LOW IMPACT HYDROPOWER INSTITUTE CERTIFICATION APPLICATION SUPPLEMENT

Molly's Falls Hydroelectric Project

This supplement to GMP's application for Low Impact Hydropower Institute (LIHI) Certification is being provided in response to LIHI's request for additional information based on Intake Review for the Molly's Falls Project.

RE: Molly's Falls Hydroelectric Project
Interim Comments on Draft Post Certificate of Public Good Plans

Figure A:
NOHRSC Data Map,
GMP Snow Core Sites (red dots),
Approximate Local Sub-Watersheds (Molly's Falls Reservoir = Green, Peacham Pond = Fuchsia)

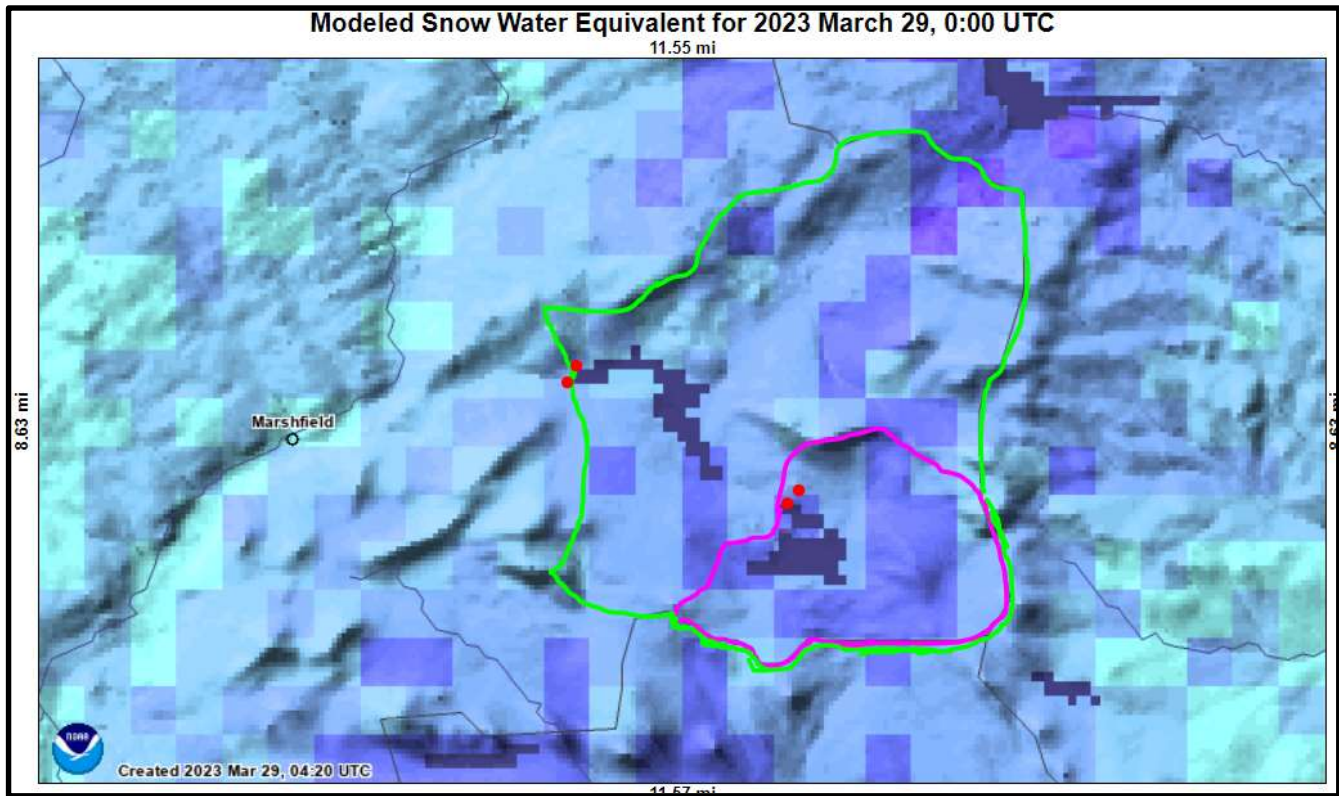
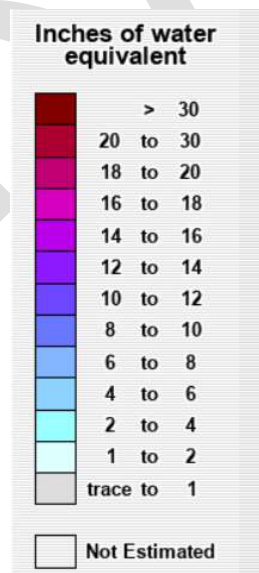
Comment: The Agency does have concerns with the comparison of measured snow pack water content with the NOHRSC estimates based on remote sensing. Based on the comparison in Table 1, the NOHRSC remote sensing data consistently overestimates snow water content in comparison to the direct measurements of snow water content.

- GMP's response states "Higher snow-water content in the NOHRSC data is expected because it includes terrain at higher elevation than the on-site cores". While this is true and makes sense that terrain at a higher elevation may tend to have higher snow-water content, isn't the reverse also true, that the NOHRSC data includes terrain at a lower elevation that may tend to have lower snow water content? Additionally, given the elevation of where snow core measurements are obtained, at a relatively high elevation in the respective watersheds, shouldn't the measured snow cores be expected to be representative of higher terrain areas that would provide a margin of safety relative to watershed wide values?*

Regarding the concept of a margin of safety, GMP believes that underestimating the amount of SWE poses the risk that actual inflows could result in excessively high water levels or unsafe operating conditions during spring snowmelt, and by estimating the watershed-wide SWE amounts GMP intends to make the most-accurate estimates feasible in order to reduce the chances of dams overtopping, or releasing excessively high flows that could cause erosive conditions downstream.

Figure C: Peacham Pond 2019-2020 Water Levels (Prior to MOU Implementation Date)

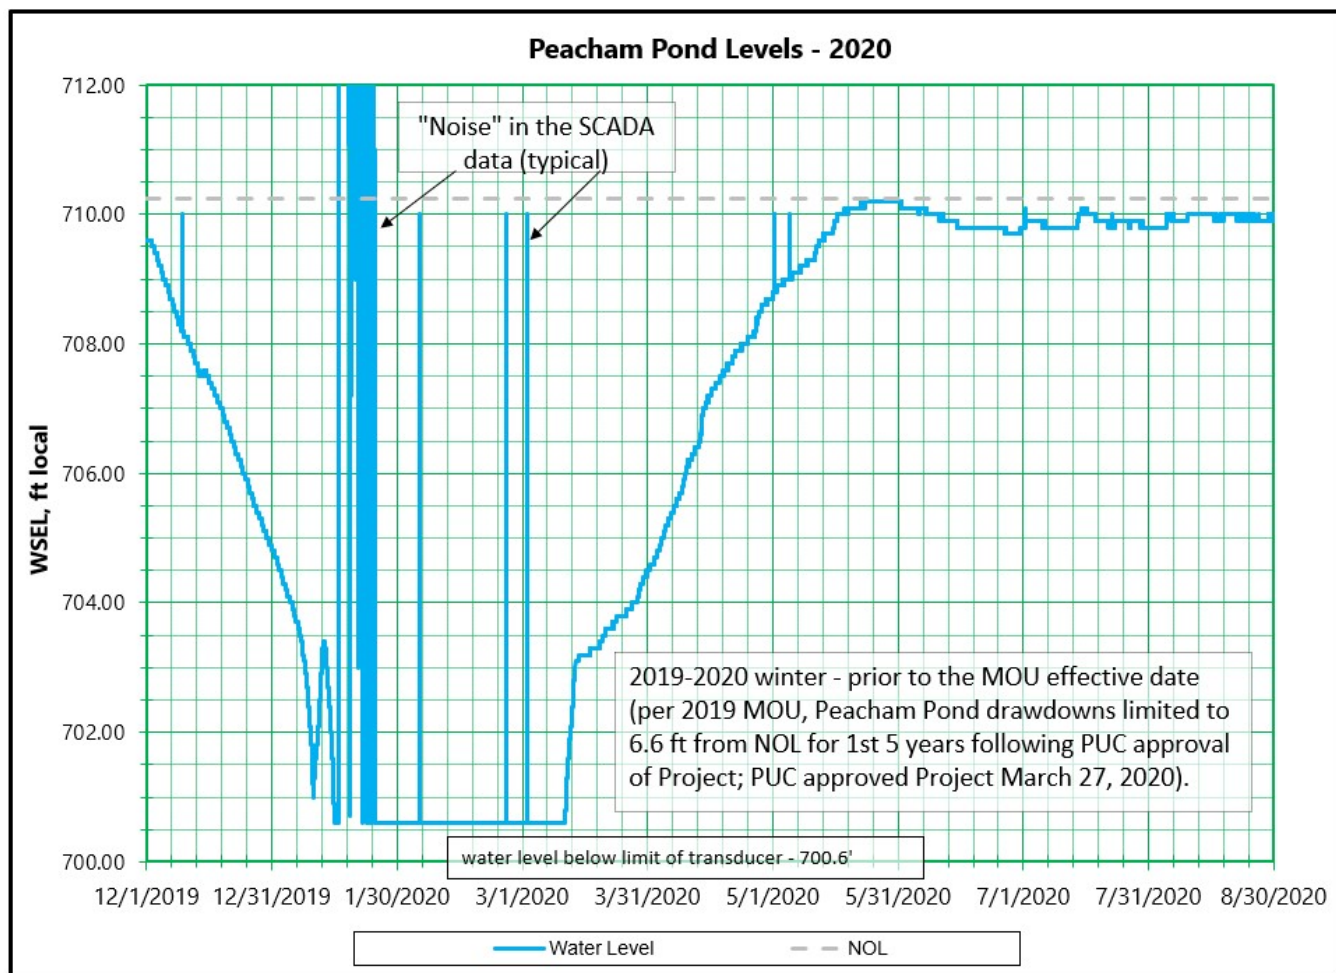
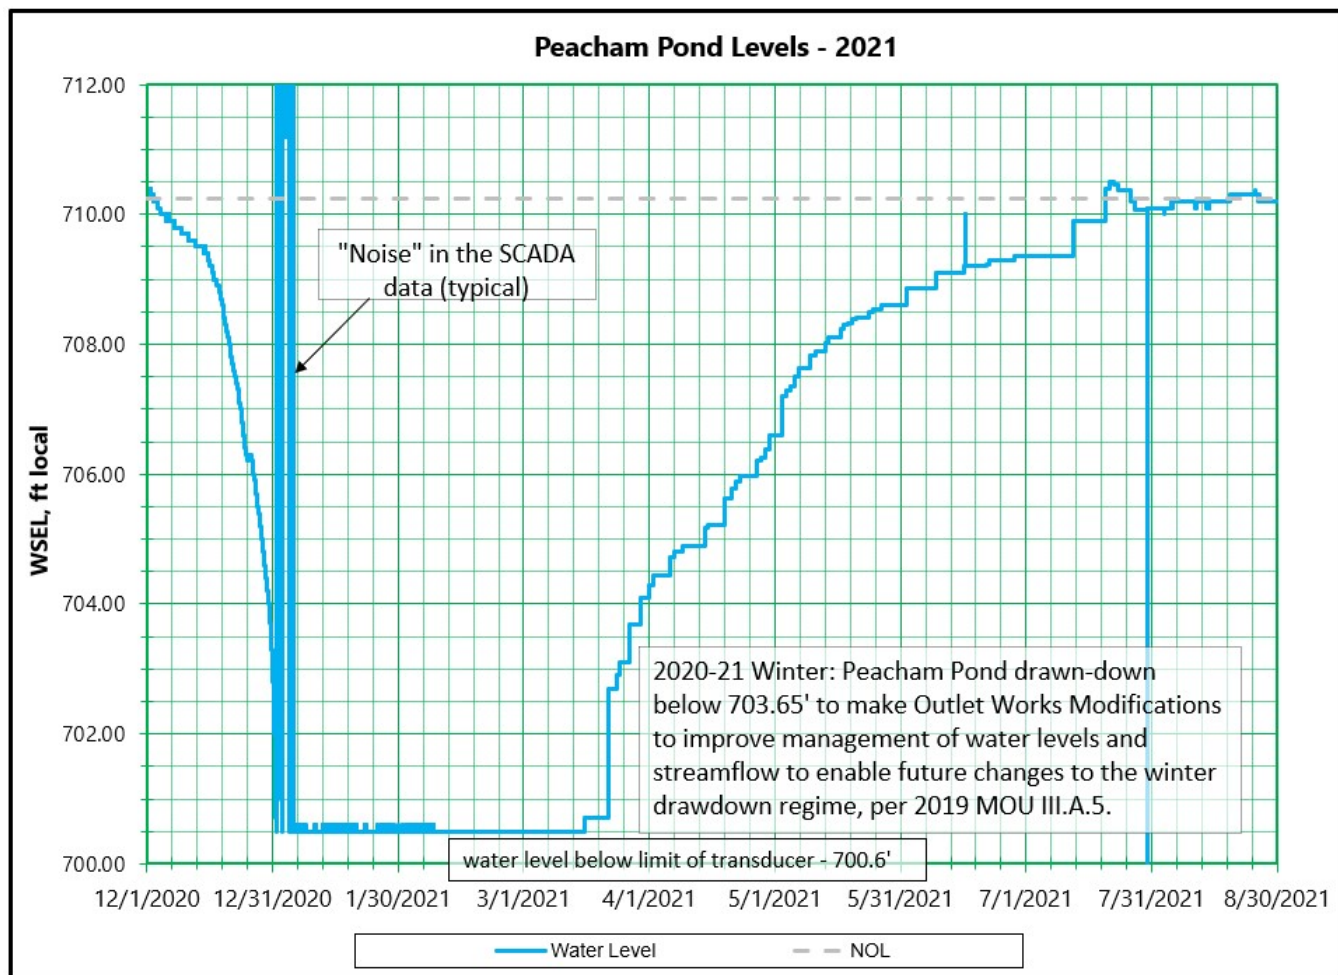
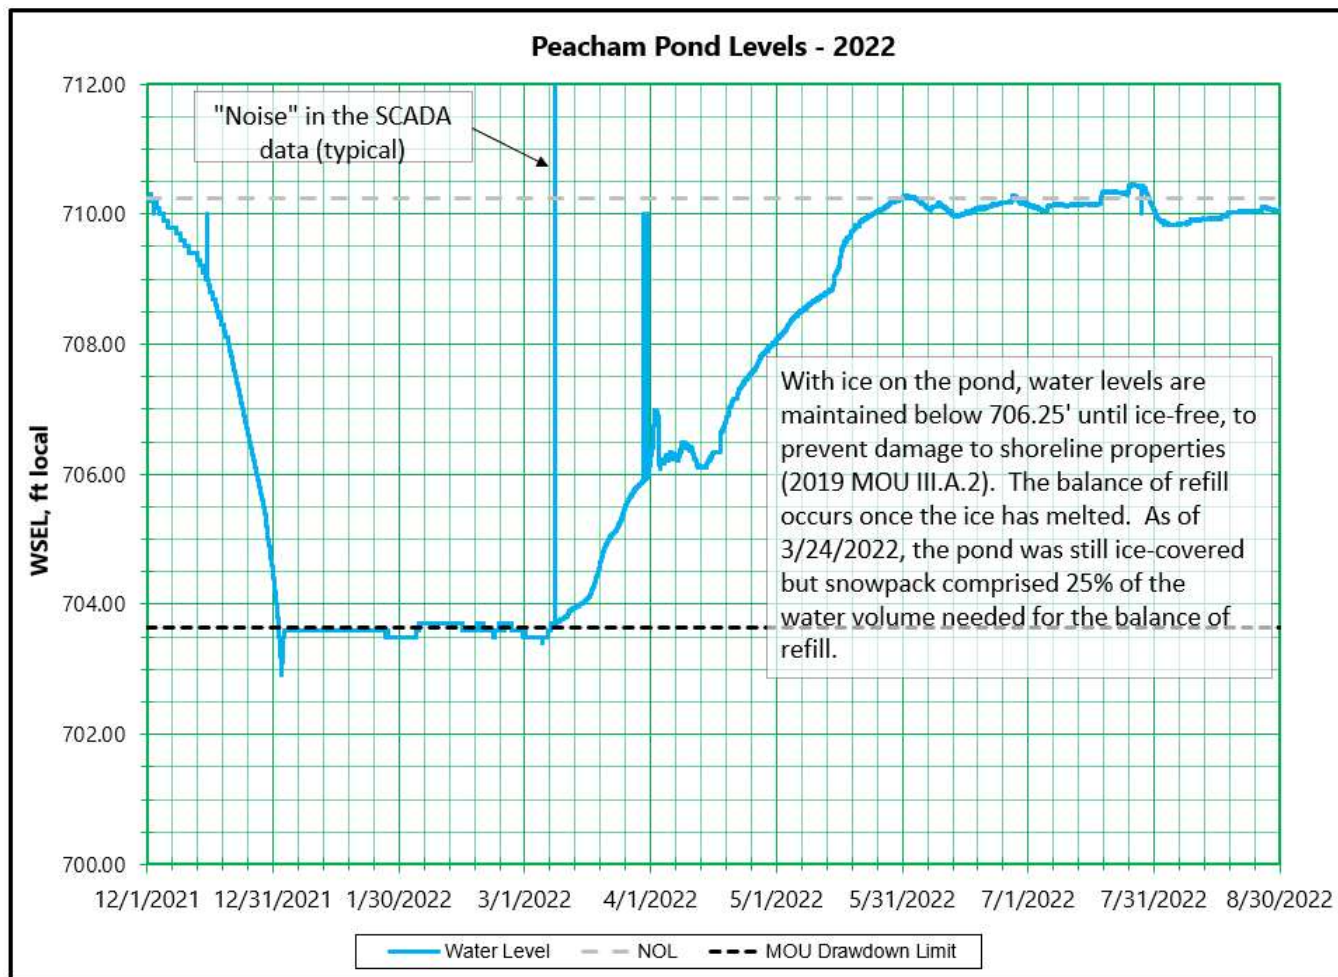
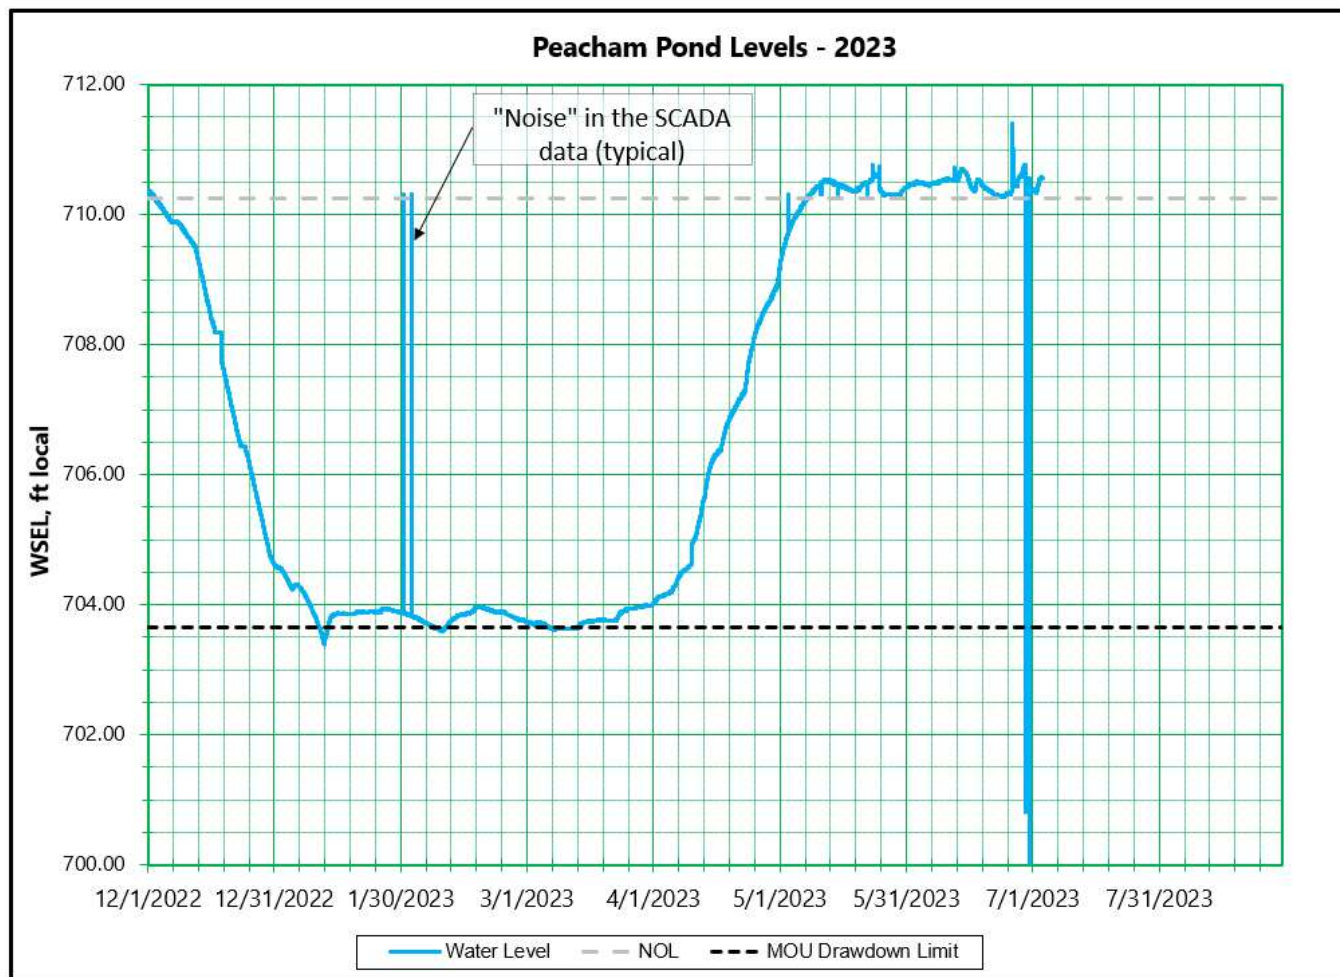
Comment: GMP's response subsequently states, "...the long-term forecasting described above was implemented for the 2019-20 and 2020-21 seasons, and has been reliable for forecasting volumes of springtime runoff for the reservoir drawdown and refill planning. No problems occurred such as overtopping spillways, releasing unsafe high flows, or failing to refill for spring/summer loon nesting and rec season, as illustrated in Figures 1 and 2:"

- The response subsequently provides figures for depicting water levels in Mollys Falls Reservoir. In contrast to the description for Mollys Falls, the Agency has heard from the residents of Peacham Pond over multiple seasons about issues with low water levels around the time of refill in the late spring / early summer. Please include similar figures for Peacham Pond to evaluate the Project as a whole. If there do appear to opportunities for refinement, this may underline our prior comment of using the validation snow water content data set to create an adjustment factor for the model inputs obtained from the NOHRSC remote sensing estimates.*

Figures C through E below depict Peacham Pond water levels for winter drawdown and spring refill.

Figure F shows a timely refill in May 2023. The information in figures C, D, and E shows Peacham Pond was refilled after May 1 for a variety of reasons including different operating procedures pre-MOU implementation, work on the outlet structure requiring additional drawdown, and ice on the pond resulting in delayed refill to prevent ice-damage to shoreline properties¹. We do not believe the accuracy of the NOHRSC snow-water equivalent data is poor, due to the explanation from NOAA provided above. Another factor in the refill forecasting, as noted in the draft Plan, is long-range precipitation forecast data from NOAA which is used to estimate precipitation during the

Figure G: Estimated Flows Based on Improved Transducer Resolution

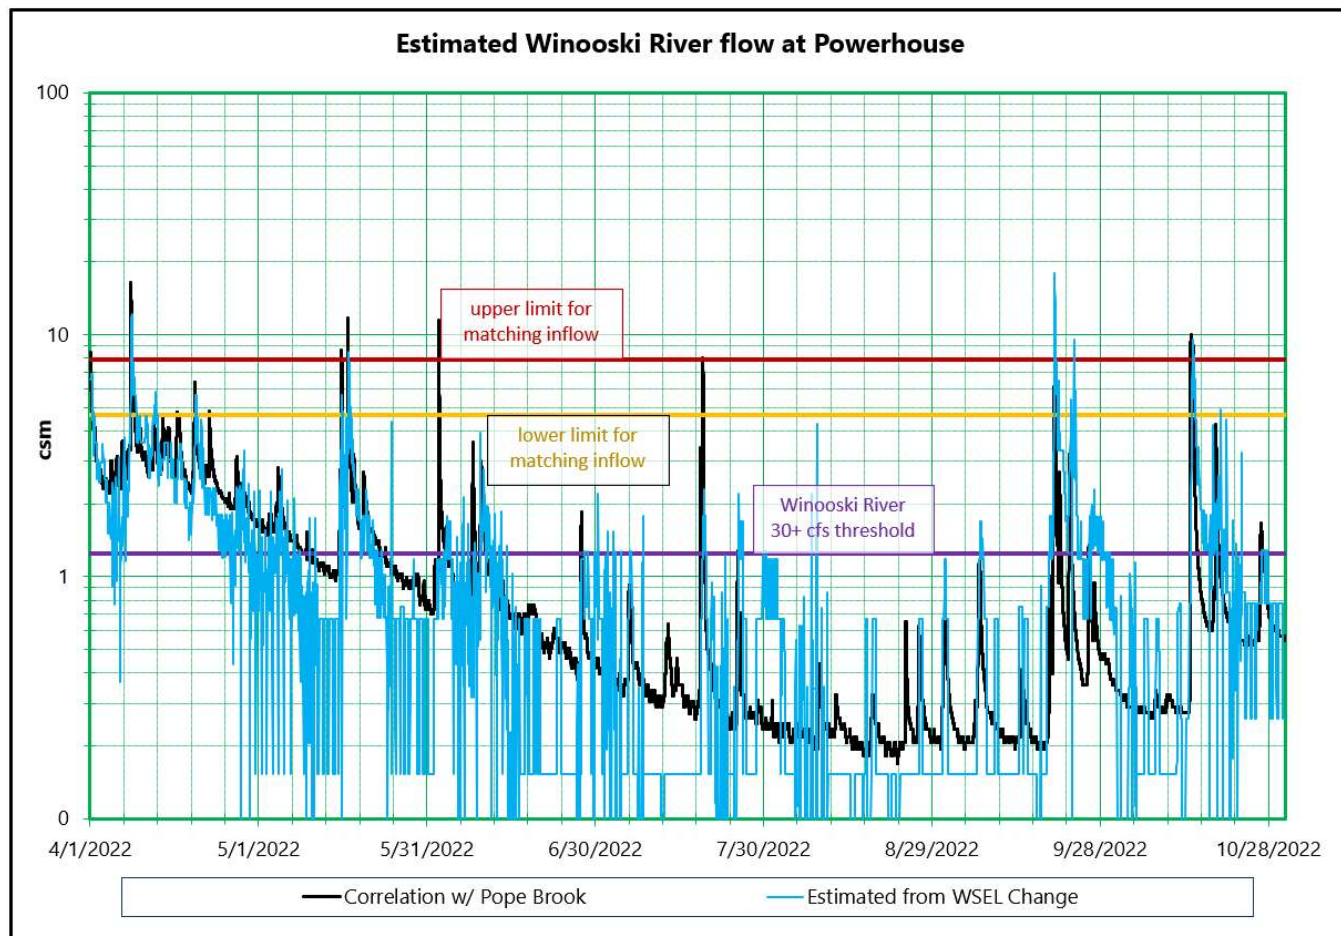
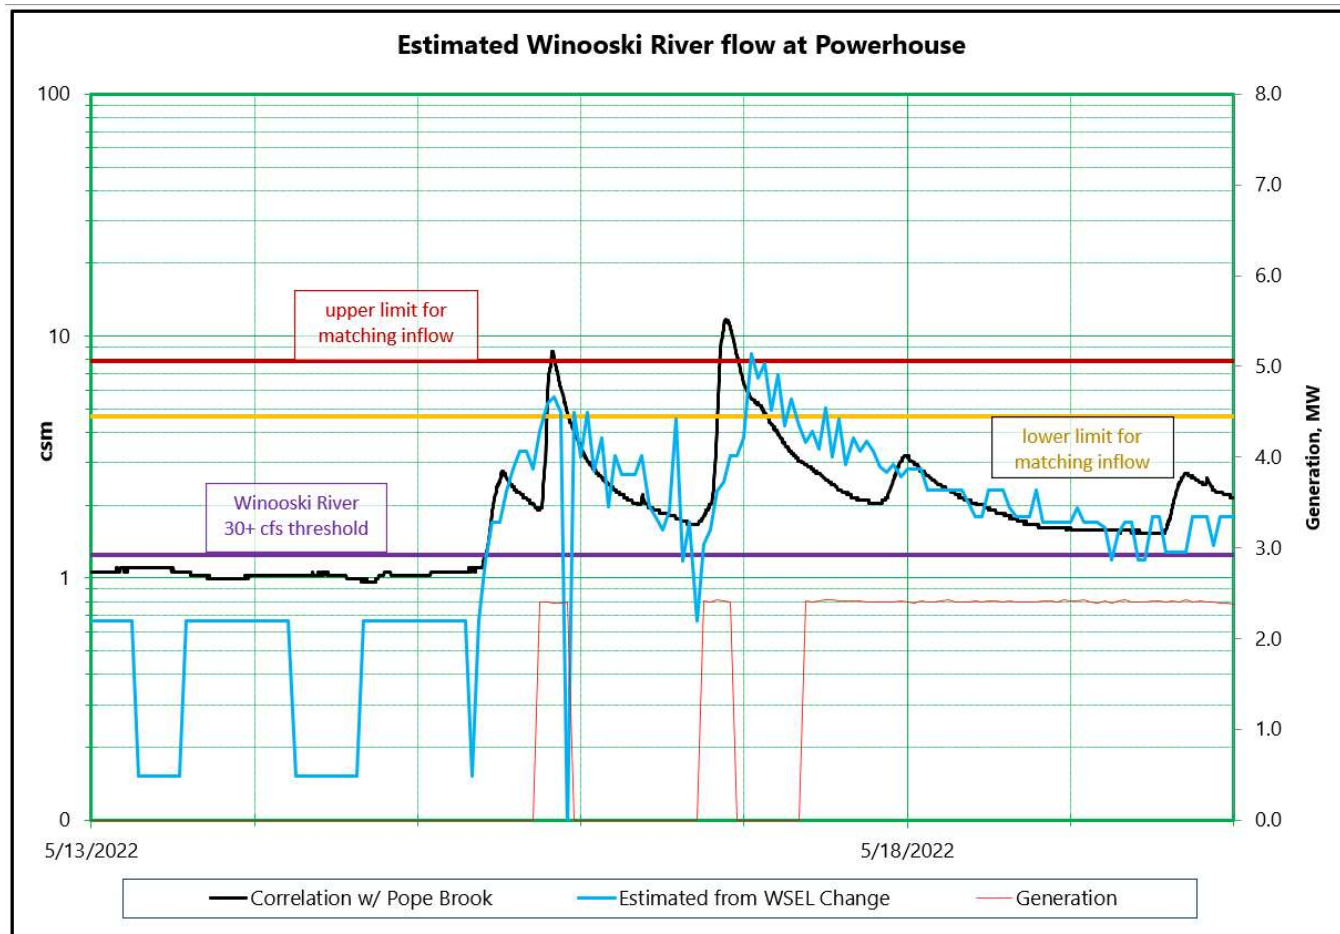
Comment: GMP's response states "Generation would not occur automatically merely because reservoir-level- rate-of-change indicates that Winooski River flows exceed 30 cfs. GMP would decide whether or not to generate when flows exceed the threshold, based on whether the apparent high-flow event is likely to persist and a reality check based on Pope Bk USGS gauge, weather at Peacham Pond/Mollys Falls Reservoir site; confirmation that Mollys Falls Reservoir Level (magnitude, regardless of rate-of-change) is high enough to support generation and meet the NOL requirements; weather forecast (i.e., are flows expected to persist or to rise further vs. decrease immediately)".

Since the methods for Reservoir Inflows and Winooski River Streamflow estimates were developed in the Plan and in GMP's 9/21/2021 response to Agency comments, GMP has improved the sensitivity of the transducer on site. The transducer can now report water levels with a nominal resolution of 0.01 feet in contrast to the resolution of 0.1 feet previously. However, the sensitivity of the transducer is limited to 0.06-foot increments. The somewhat improved transducer sensitivity results in less "noise" in the inflow estimates and some improvement in the accuracy.

VHB analyzed the new transducer data for the period from April 1 through October 31, 2022. The April through October period is the interval in which the MOU specifies that generation may occur if Winooski River flows at the powerhouse exceed 30 cfs (with the potential to use the change in reservoir levels to indicate the streamflows). This interval from 2022 is the most-recent complete April-through-October period with new transducer data. During this period, estimated Winooski River flow at the Powerhouse, based on Mollys Falls Reservoir level changes, exceeded 30 cfs for a total duration of 1,312 hours. Based on the Pope Brook flows, it exceeded 30 cfs for a total duration of 1,284 hours during the same period.

Figures G and H below depict the Winooski River flows at the powerhouse, as estimated by both the reservoir-level change method, and the correlation with current USGS data from the Pope Brook gauge. Although there is frequent "noise" in the reservoir-level change data at lower flows, the timing and duration of events above the 30-cfs threshold is similar between the two methods.
